Addendum No. 3, June 11, 2025

Re: Johnson Hall Renovation – PKG 3
Johnson Hall Renovation & Foster Demolition
Tennessee Technological University
SBC Project No. 364/011-04-2022CM

From: Upland Design Group, Inc.
P.O. Box 1026 (38557)
362 Industrial Blvd.
Crossville, TN 38555
Telephone (931) 484 7541
Fax (931) 484 2351

A3.02

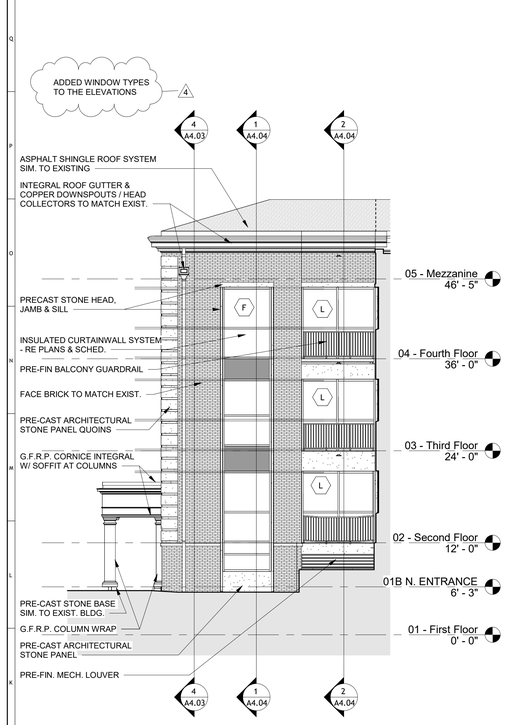
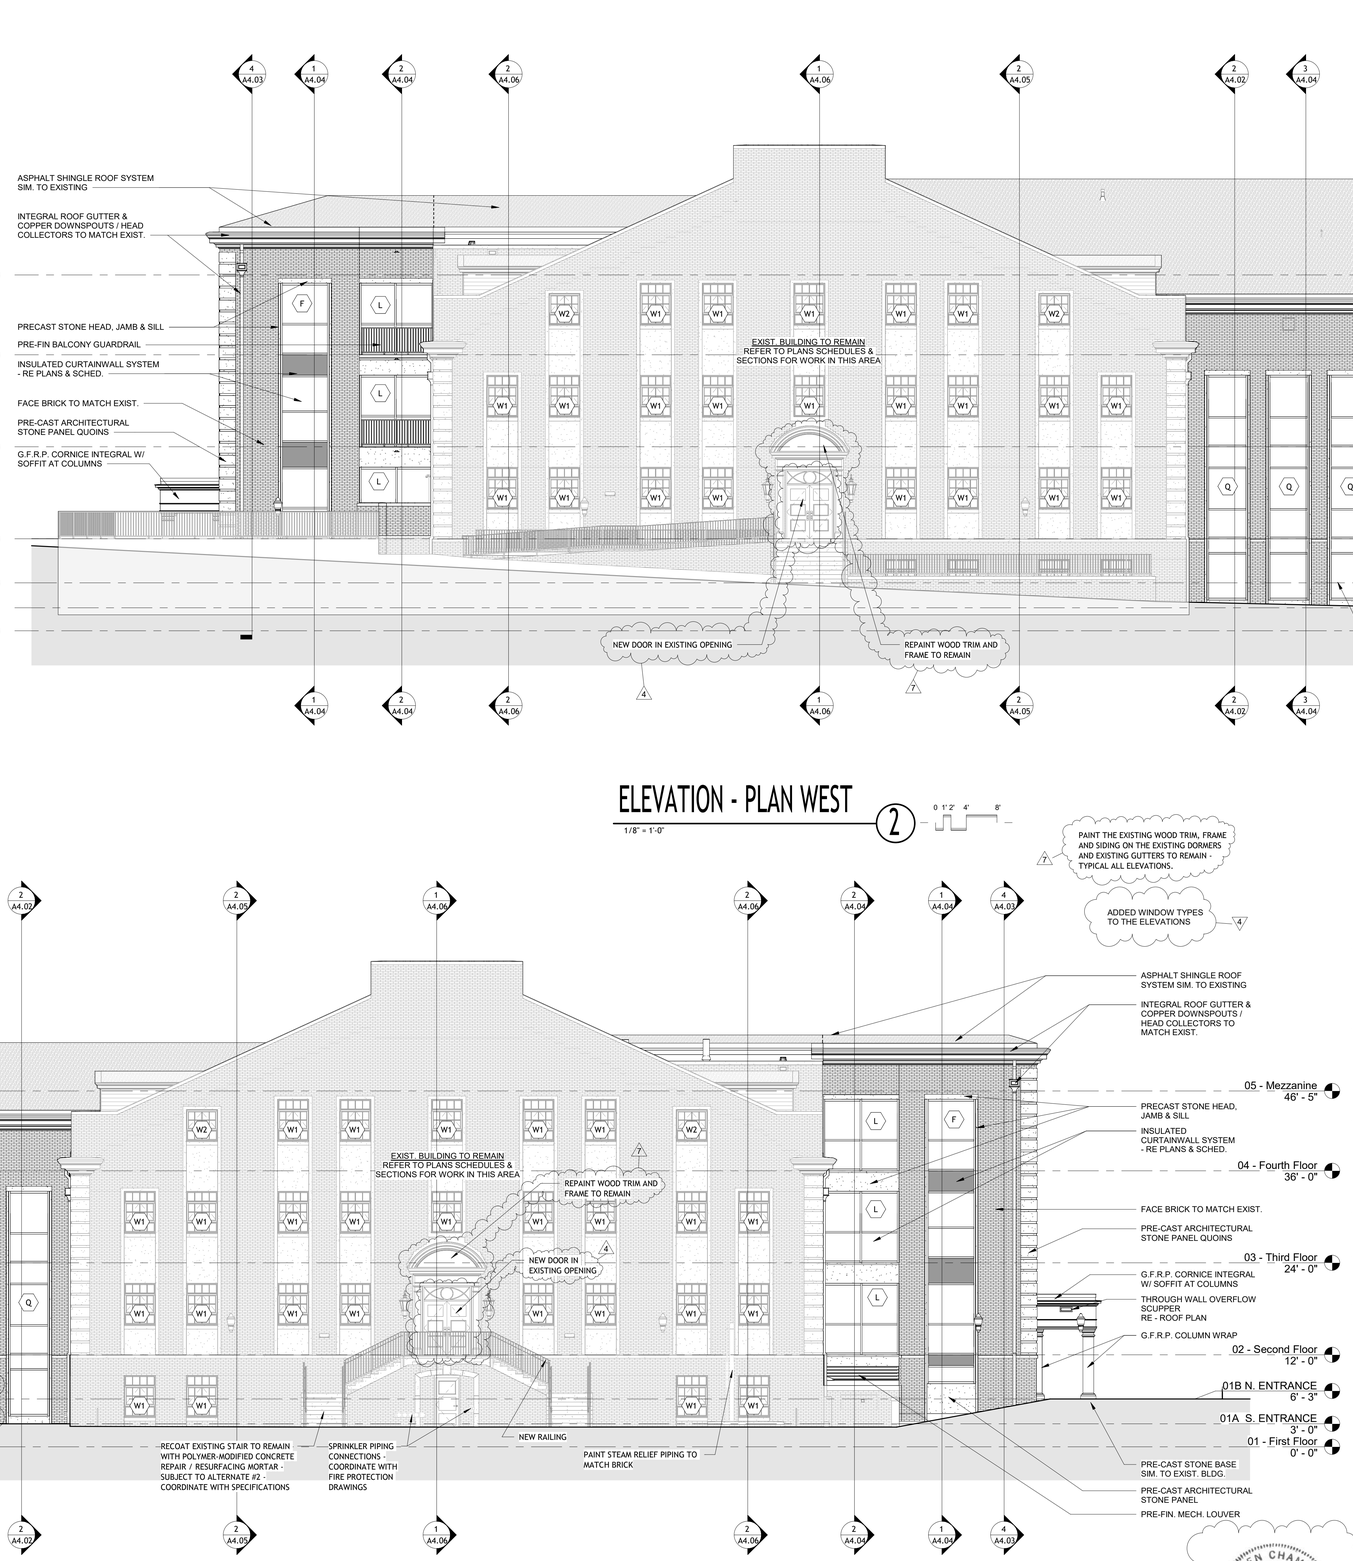
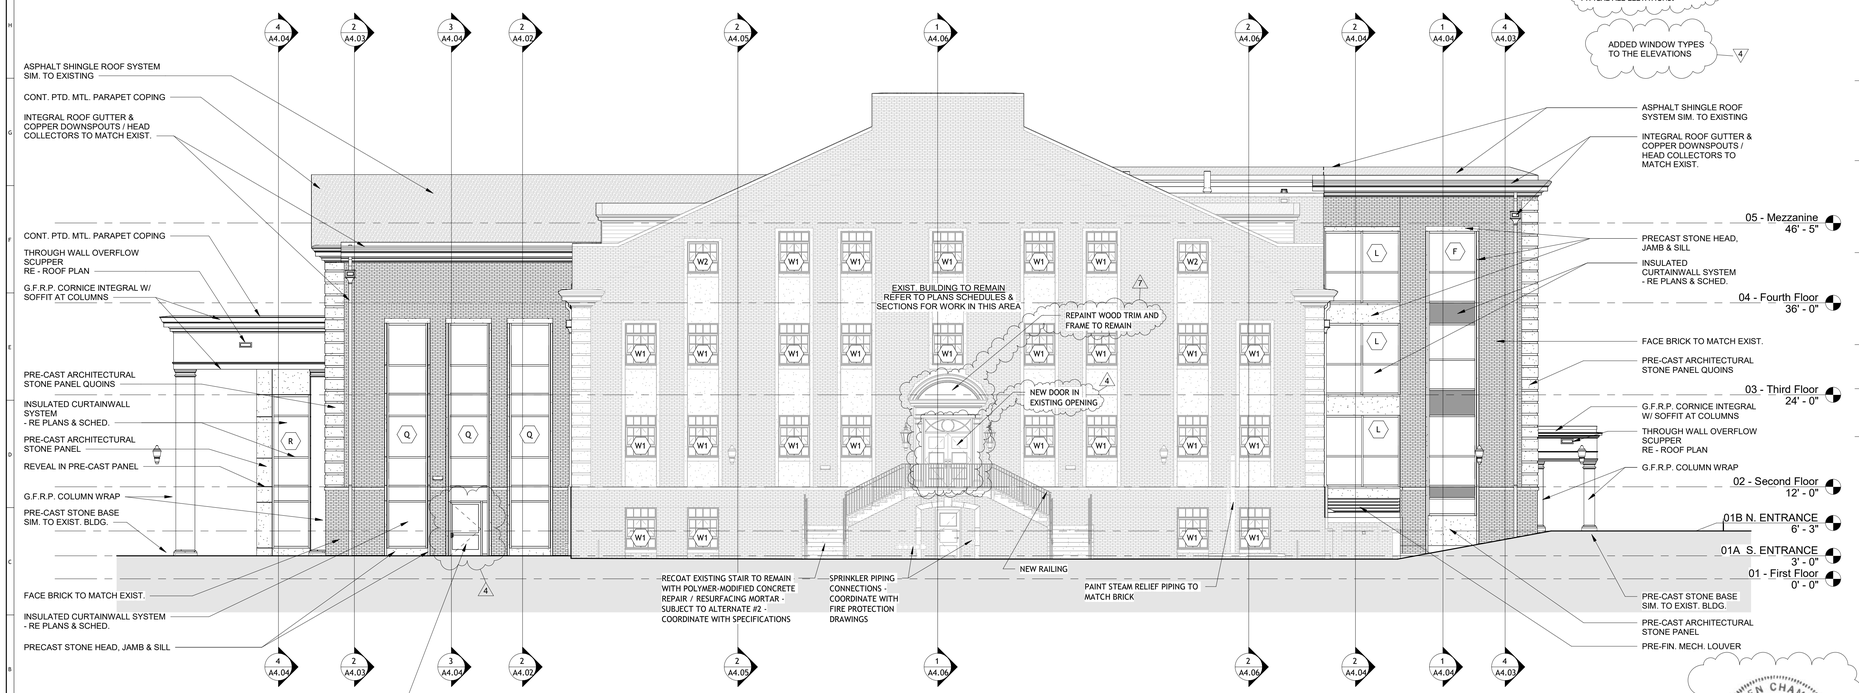
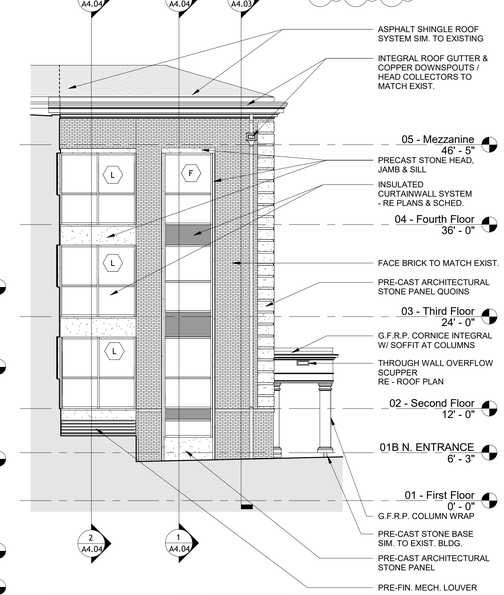
23) Refer to sheets A3.01 Exterior Elevations and A3.02 Exterior Elevations. Add the general note “Paint the existing wood trim, frame and siding on the existing dormers and existing gutters to remain – typical all elevations” to all elevations.

24) Refer to sheets A3.02 Exterior Elevations. Repaint wood trim and frame to remain for second floor doors on the plan east and west elevations.
25) Refer to sheets A6.05 and A6.06 Interior Elevations, Large Format Tile Legend. Change legend to have tile 1 read “Large Format Wall Tile Panels – 24”x48” Field color – coordinate with finish plans.” And have tile 2 read “Not Used.” Remove references to Tile 2 from interior elevations 1/A6.05, 2/A6.05, 3/A6.05, 4/A6.05, 5/A6.06, 6/A6.06, and 7/A6.06. Add grout lines to tile 1 as shown on attached revised sheets.

REFLECTED CEILING PLAN - 1st FLR

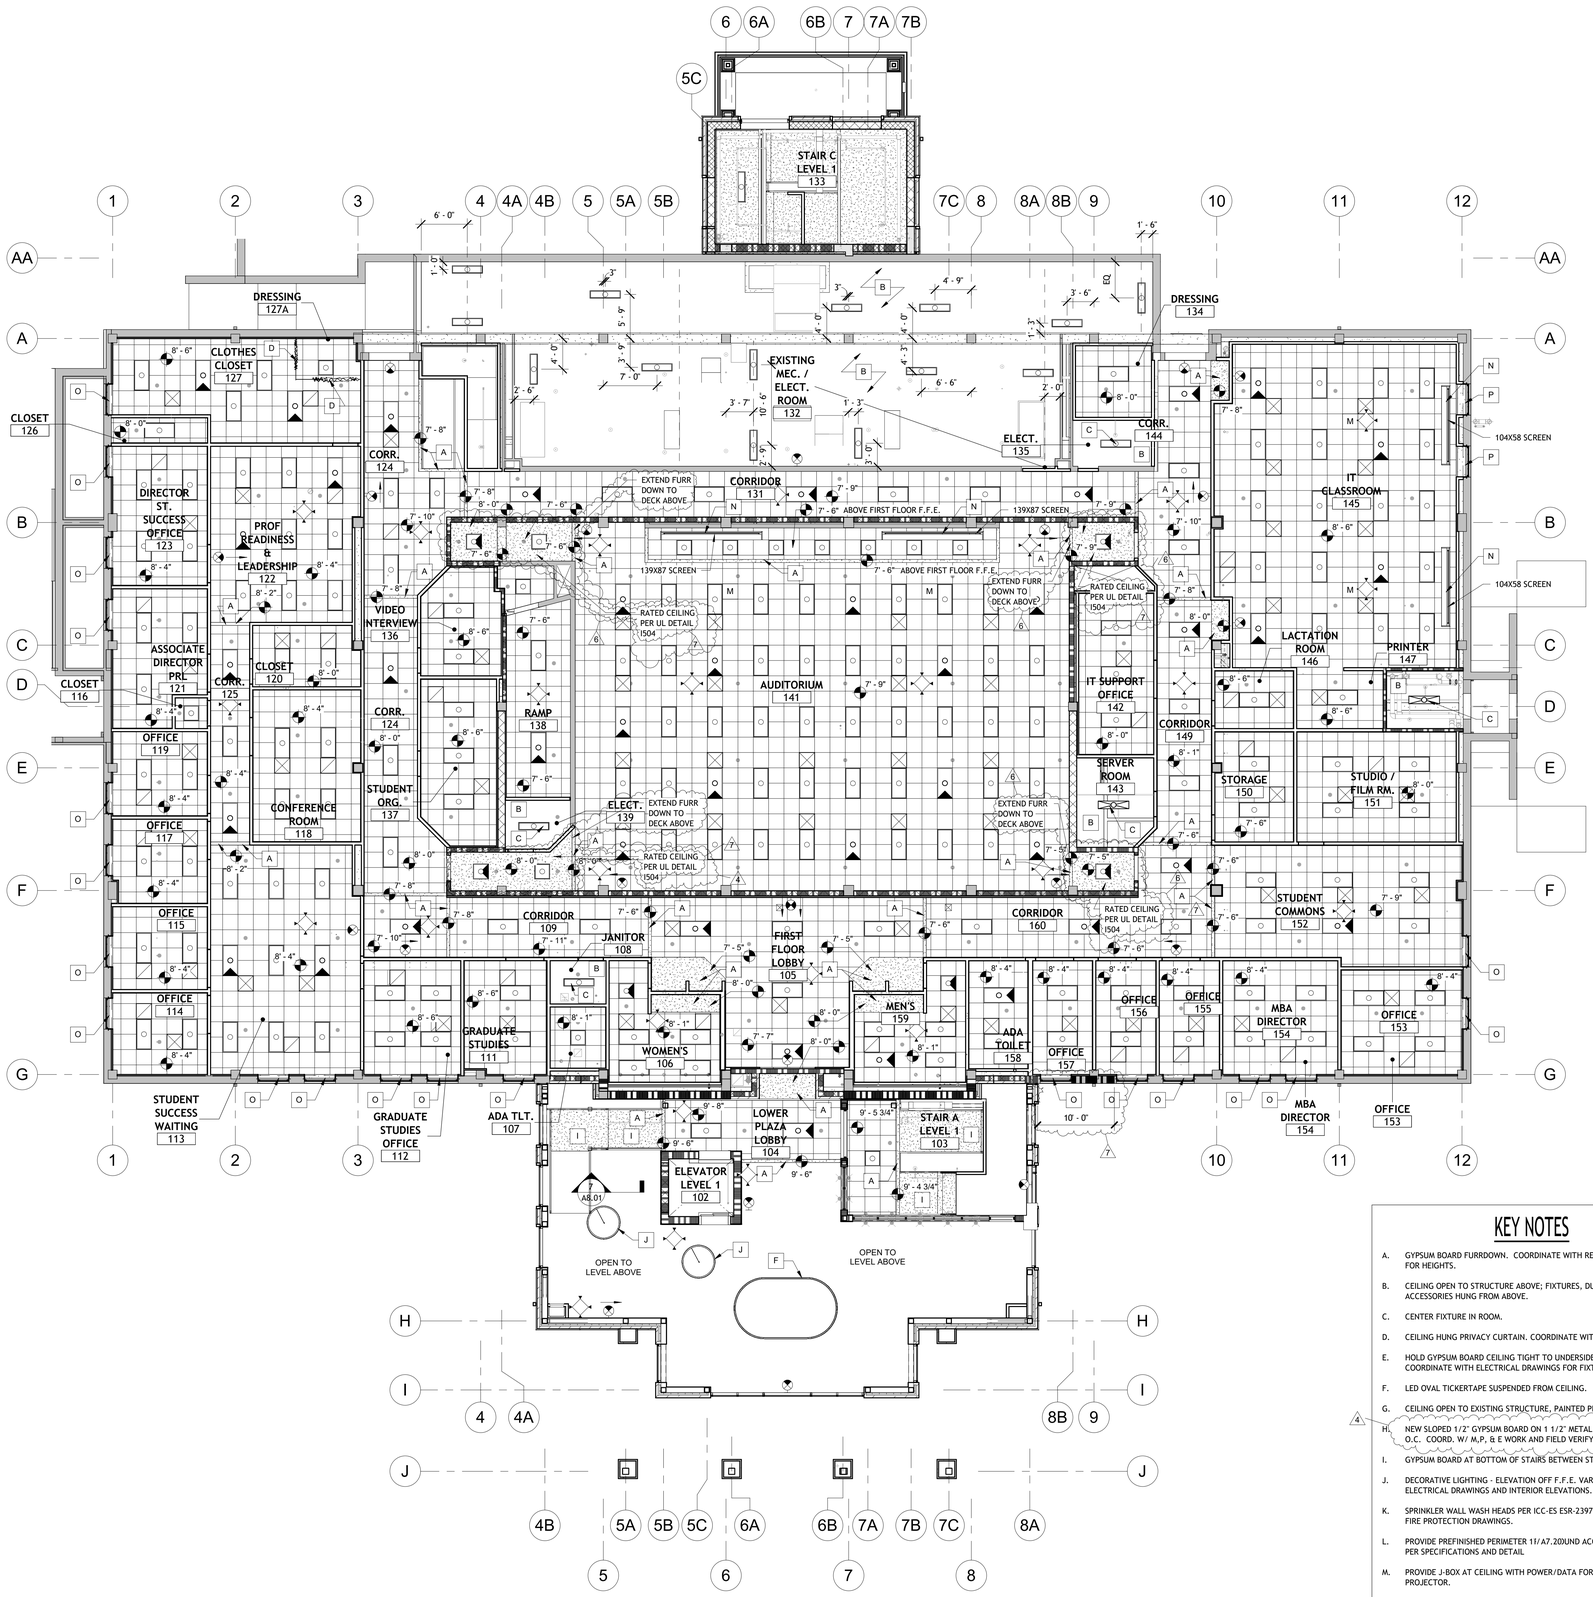
3) The rated ceilings in Auditorium 141 have been changed to match UL detail I504's requirements. See attached revised UL sheet on Revised GN2.2 UL Pages.

26) Refer to sheet A7.10 Reflected Ceiling Plans – First Floor. Change the note at the hard ceilings in Auditorium 141 to read “Rated Ceiling per UL Detail I504”.

2ND FLOOR REFLECTED CEILING PLAN

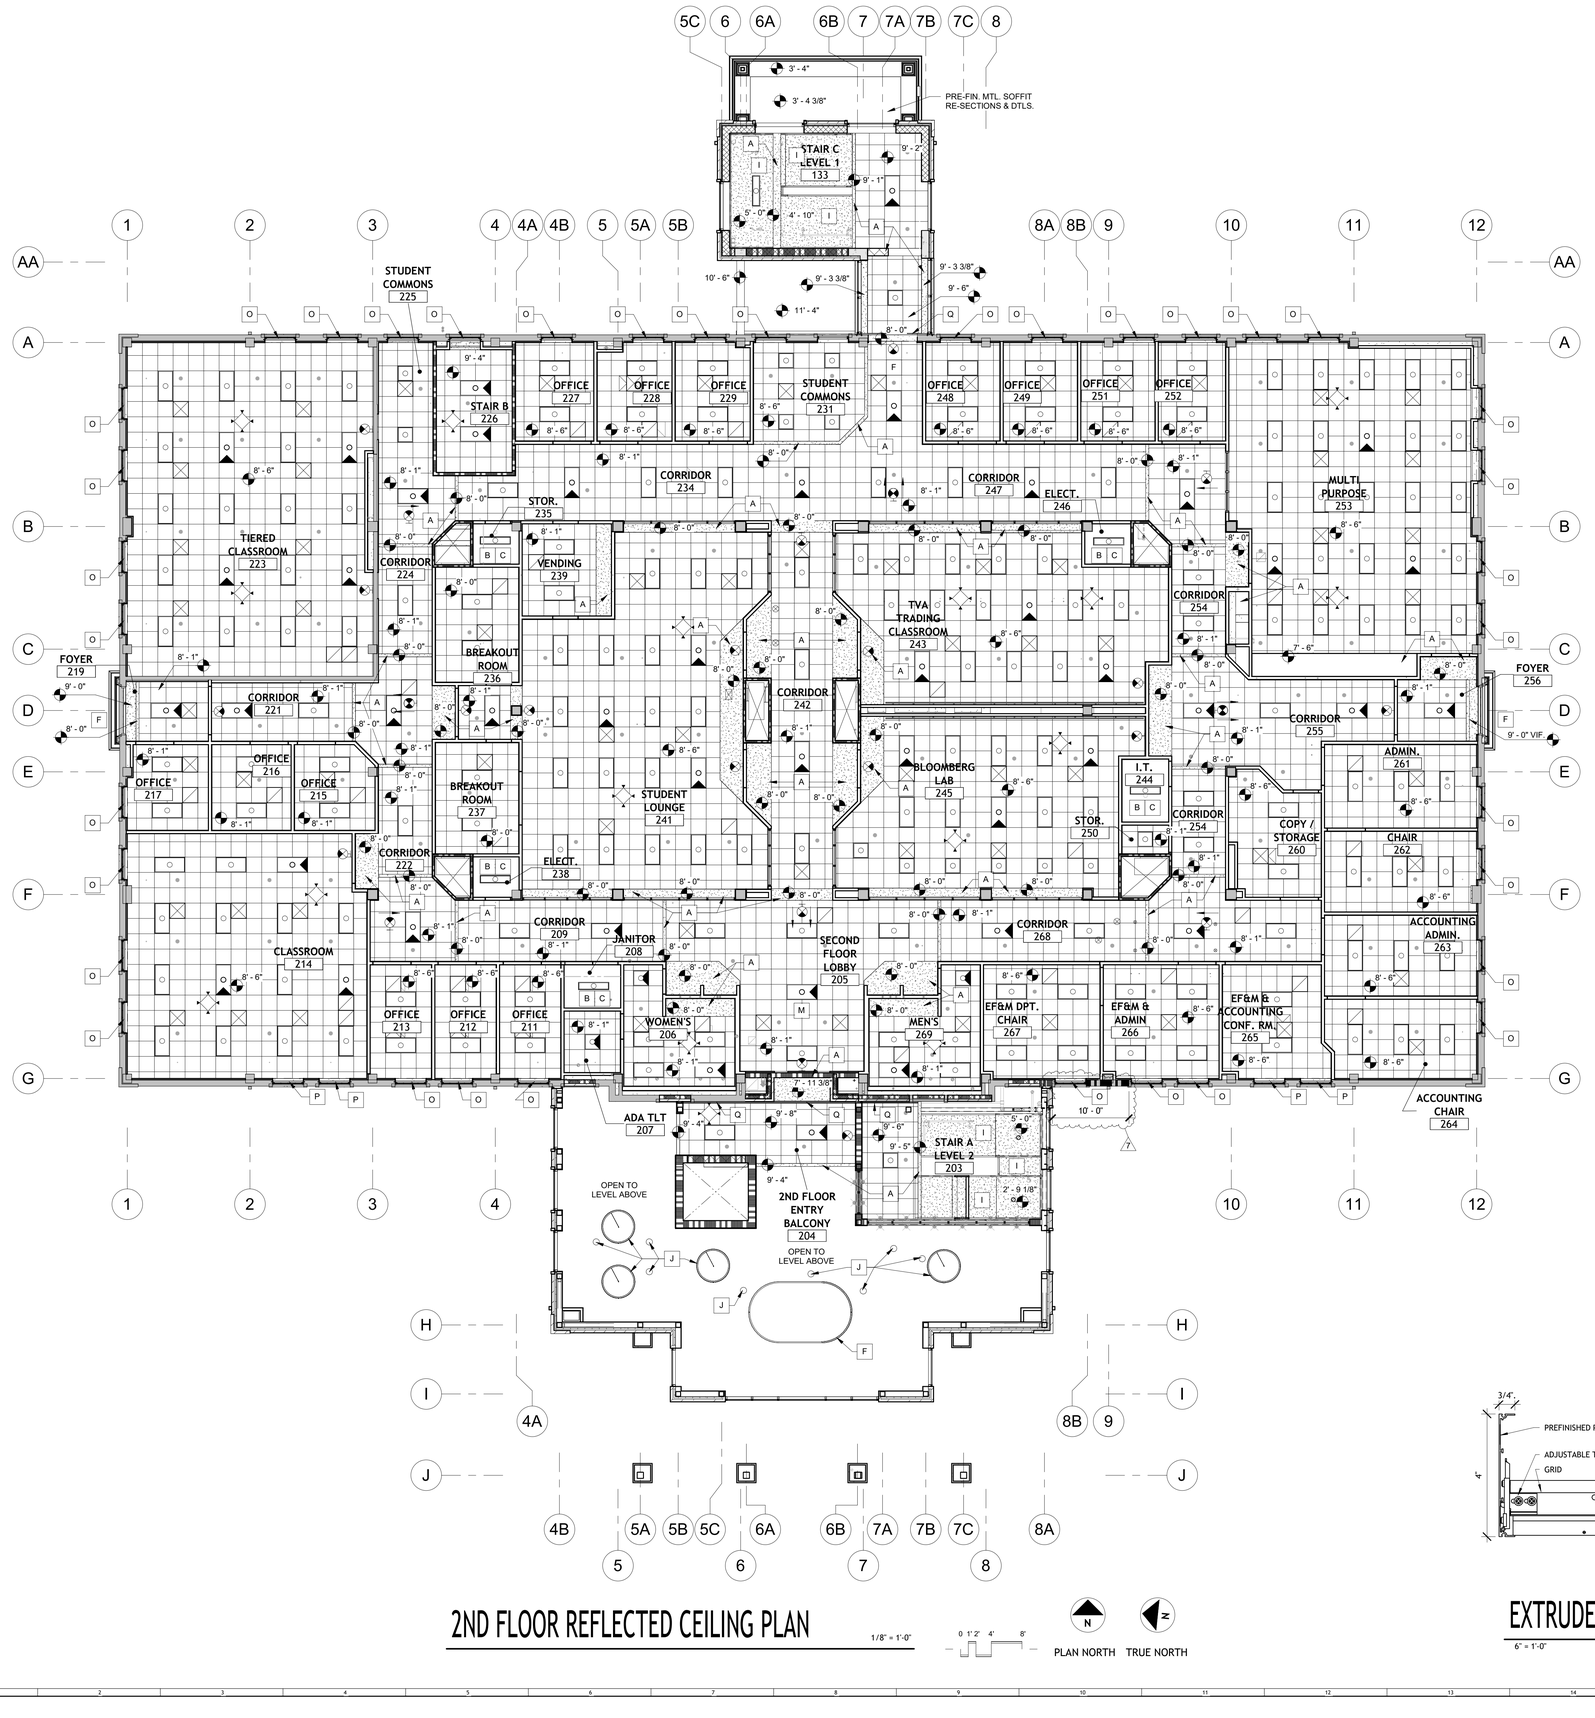
17) Refer to sheets A1.1D, A1.1N, A1.2D, A1.2N, A1.3D, A1.3N, A1.21, A1.22, A1.23, A1.31, A1.32, A1.61, A3.01, A7.10, A7.20, and A7.30. Add 1-hour fire rating to the first 10 feet of the plan east side of the new lobby addition per the attached revised sheets.
